Strata DK40i R4.1 to R4.3 Upgrade

This bulletin provides an overview of the upgrade features, and provides database backup instructions. It also contains instructions on how to upgrade the Strata DK40i R4.1 system.

Figure 1 DK40i Base KSU Interior

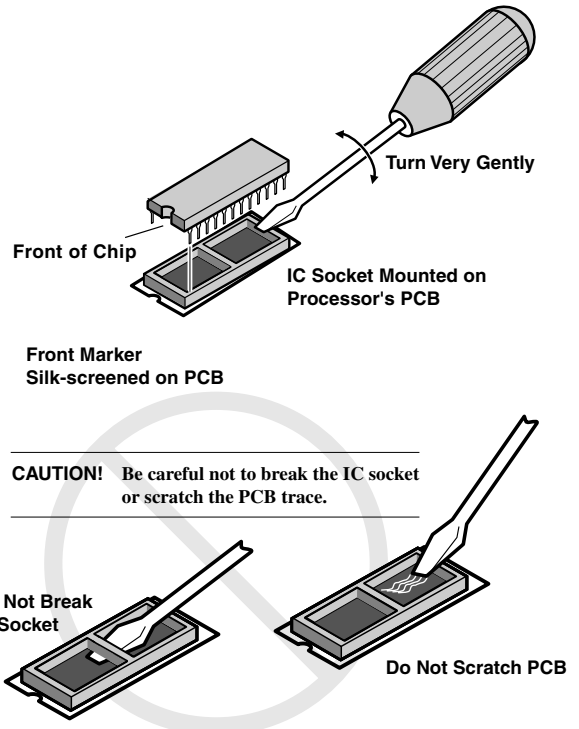
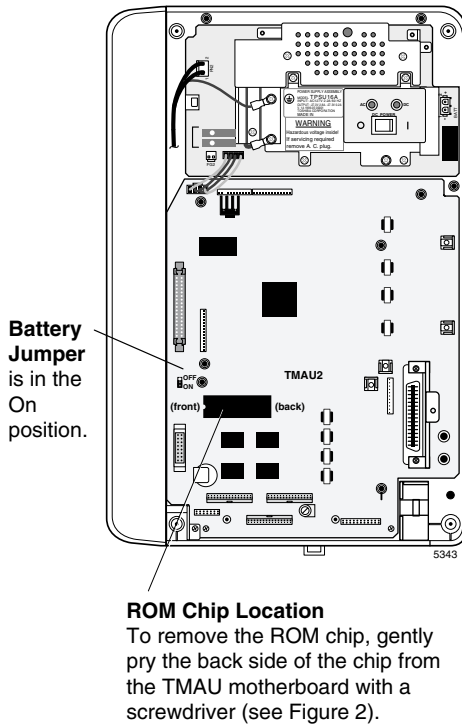
4. Remove the DK40i KSU from wall.
5. If present, remove the KSTU2 from the KSU motherboard (TMAU2).
6. With an IC removal tool or flat tip screwdriver, very carefully remove the existing ROM from the TMAU motherboard per [Figures 1](#) and [2](#).
7. Hold the new ROM by the edges and align it with the ROM socket. Make sure the front and back are in the correct position, then carefully insert the ROM into the socket. Press the ROM firmly, making sure all pins are inserted properly.
8. Re-install the items removed in sub-steps 1~5.
9. Turn on the DK40i and use a test telephone to verify that the KSU is functioning.

Figure 3 Upgrade Sticker Location

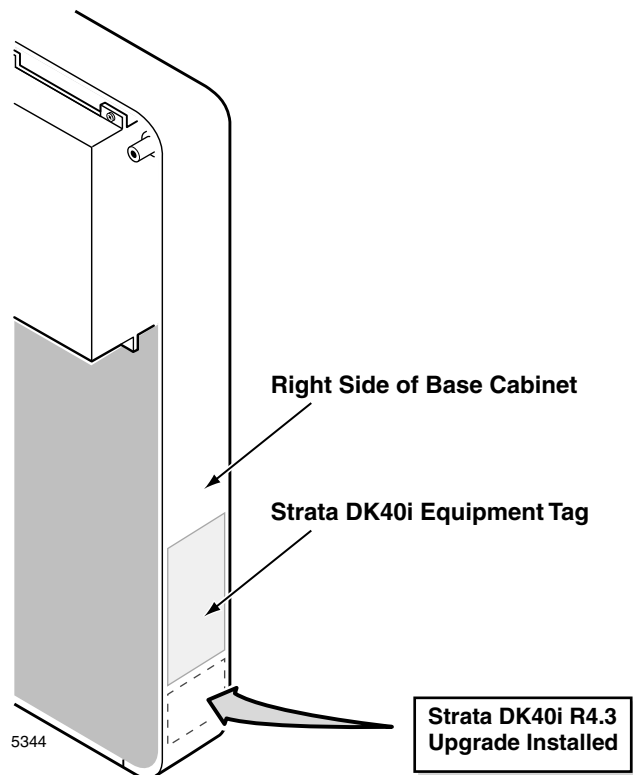
- Apply the supplied cabinet identification sticker below the DK40i equipment label on the right side of the base cabinet cover (see [Figure 3](#)).
